DEPARTMENT OF THE ARMY
NEW ORLEANS DISTRICT, CORPS OF ENGINEERS
P.O. BOX 60267
NEW ORLEANS, LOUISIANA 70160-0267

SUBJECT: (Emergency Permit) NOD-20
BASE FILE: MVN-2010-1271-EOO

Department of the Army Permit Evaluation
And Decision Document

Application No.: MVN-2010-1271-EOO

QUATRE BAYOU PASS
EXPOSED PIPELINES
JEFFERSON PARISH ROCK PLAN
GROUND ISSUE, LA

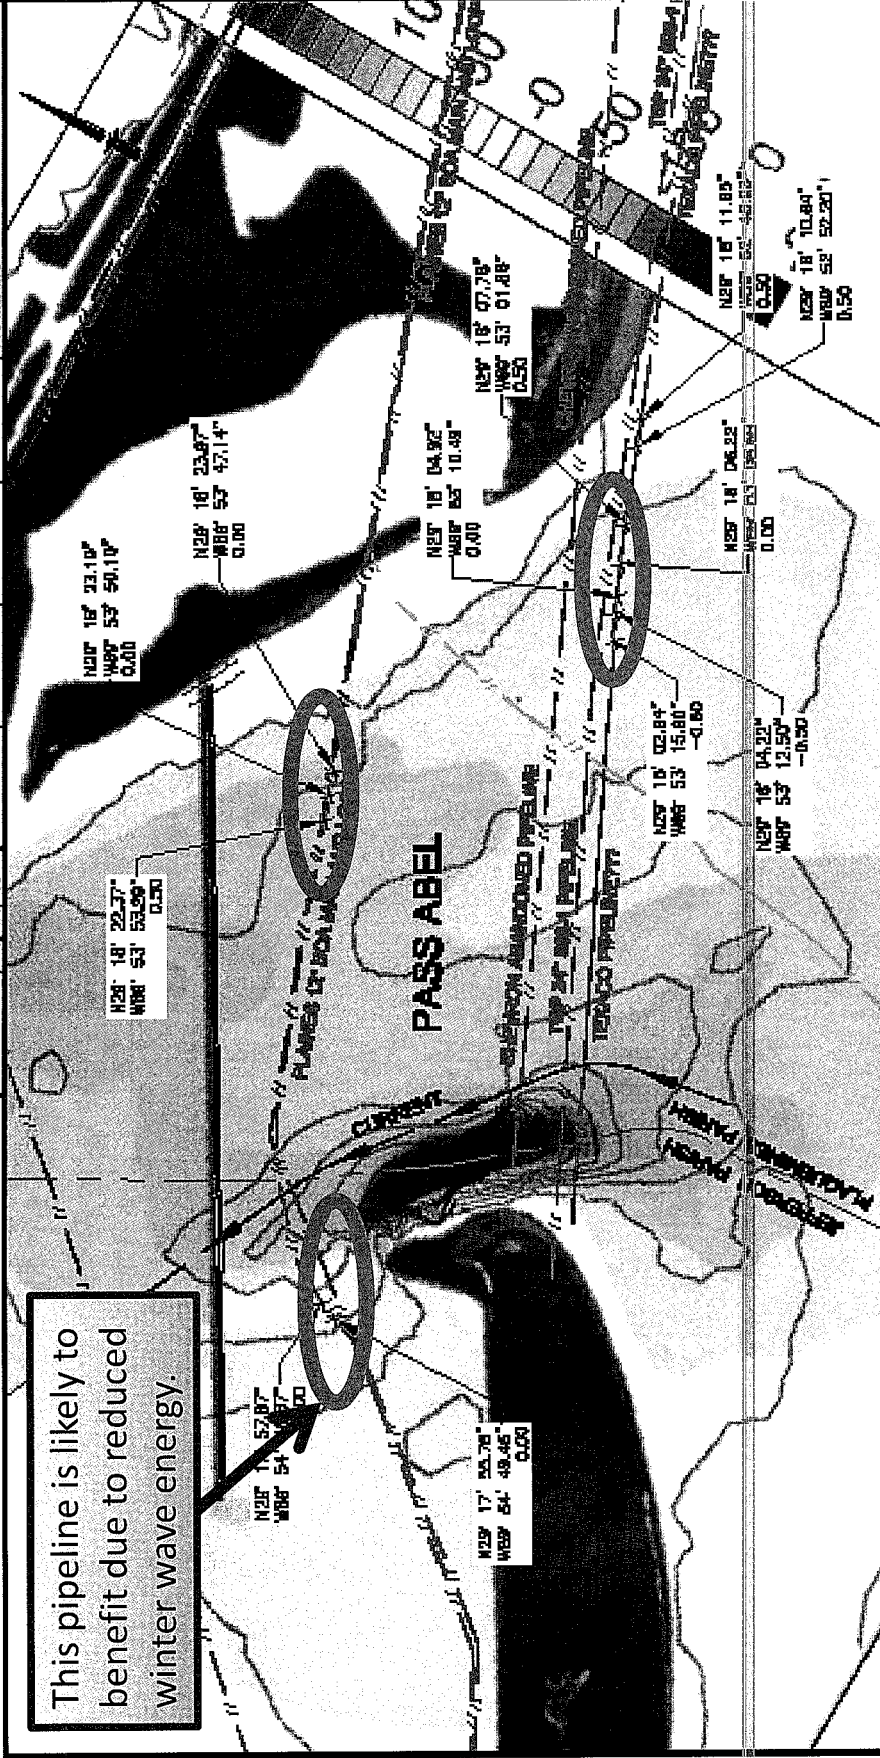
This pipeline is likely to benefit due to reduced winter wave energy.

Figure 1. Locations with Water Surface Elevation Point Comparisons.

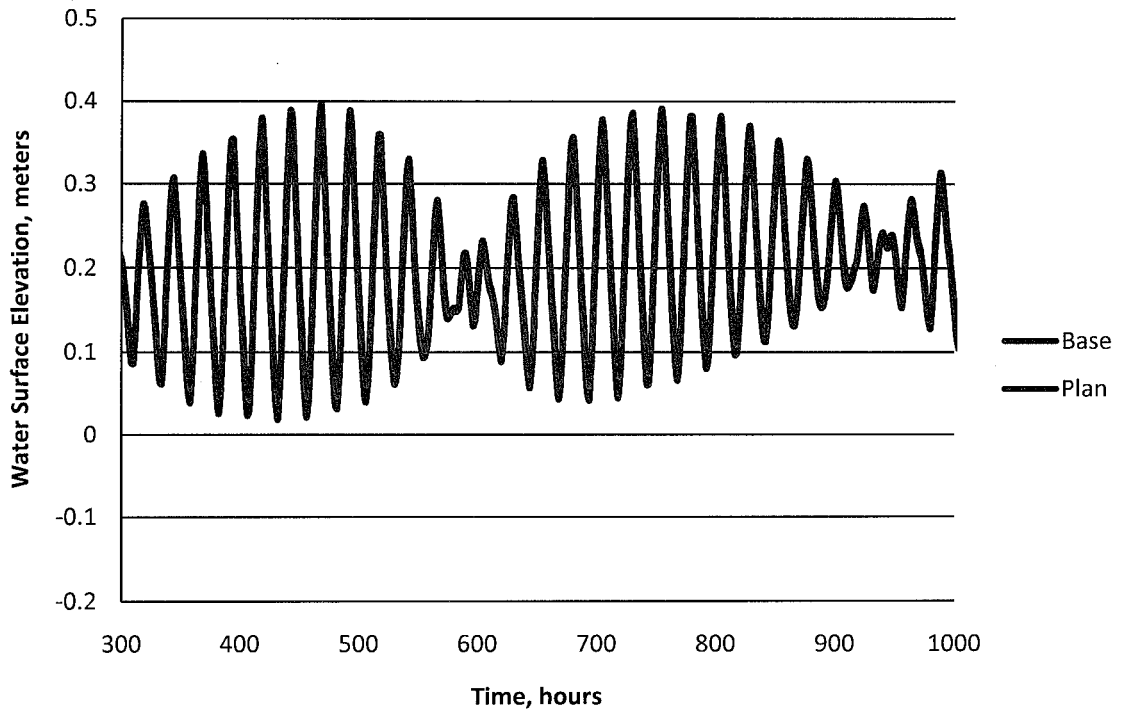
From our modeling effort, we observe a number of reactions to the constricting Pass A Bel and Four Bayou Pass. These include:

- 1) Slight lowering of the tide ranges North of the passes (see time series water level data). The largest differences in the tide ranges are just north of the passes with the changes being reduced as the tide progresses inland.
- 2) Slight differences in the wetted areas for the high and low water levels.
- 3) There is a redistribution of flow through the passes with Barataria Pass possessing higher velocities for the plan configuration.

Figure 1 pre-post velocity profiles and impacts on operations

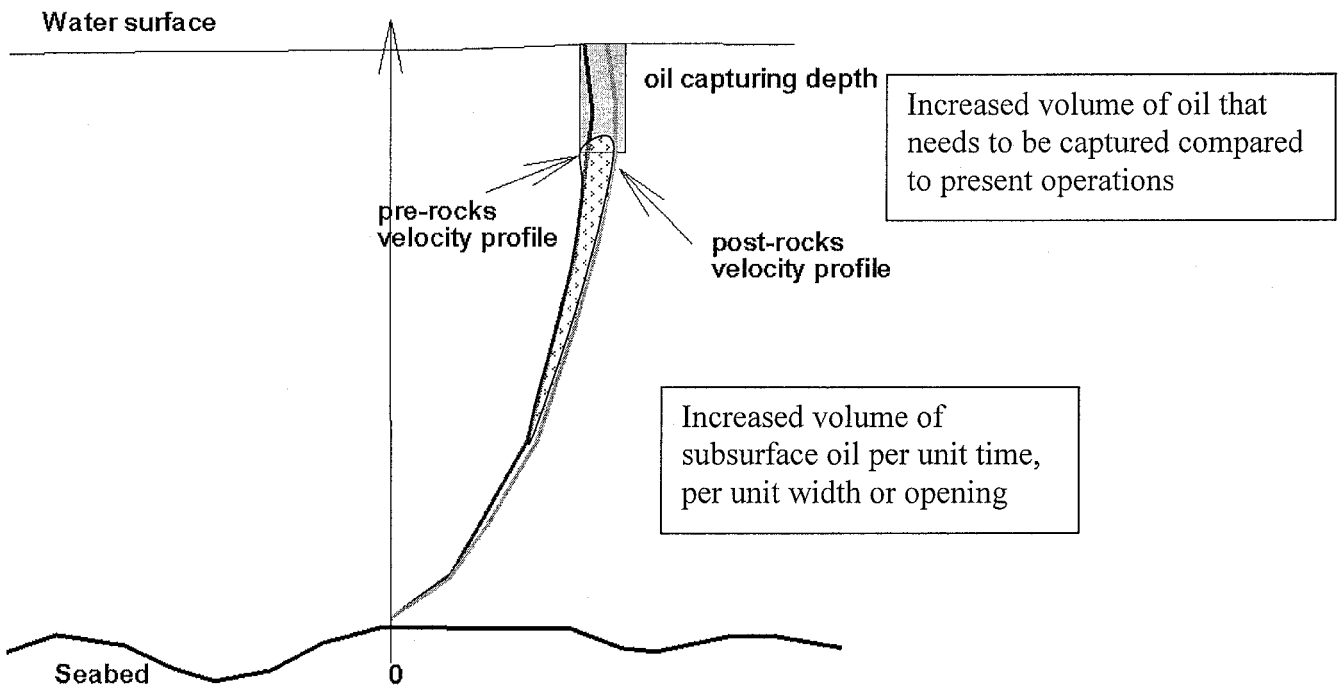
- a. The faster currents will change the velocity profile (figure 1), and inadvertently increase the volume that skimmers would have to pump, per unit time during flood currents (gray box in fig 1)

- b. The area below the gray box, integrated and subtracted from the pre-rock placement profile, would also increase the amount of subsurface oil coming through these inlets.

| <p>Response to 3.13-3.16: 2.18. We appreciate the opportunity to use of the sketch prepared by Dr Ioannis Georgiou to explain the mechanics of possible reduction of oil propagation through the Passes. Maximum velocities (V) at the passes without barrier are in excess of <u>4 ft per second</u>. The passes are very wide: Pass Abel is more than 7,000 ft in width. One can compute a possible huge amount of oil that currently or in the future can propagate into the bay. Excluding velocities for most of the length of the pass (making V=0 and making B post <<< B pre-project would exclude a significant amount of oil from entering the pass. In addition, modeling showed that construction of the dike would reduce in more than a 65% decrease in the flow volume at Pass Abel ($V1*B*C$; the total amount of water and oil that enter the bay) and more than a 35% reduction in volume at Quatre Bayou Pass. This means that there is an overall reduction of the oil entering the bay through these passes.</p> | | | | | | | |
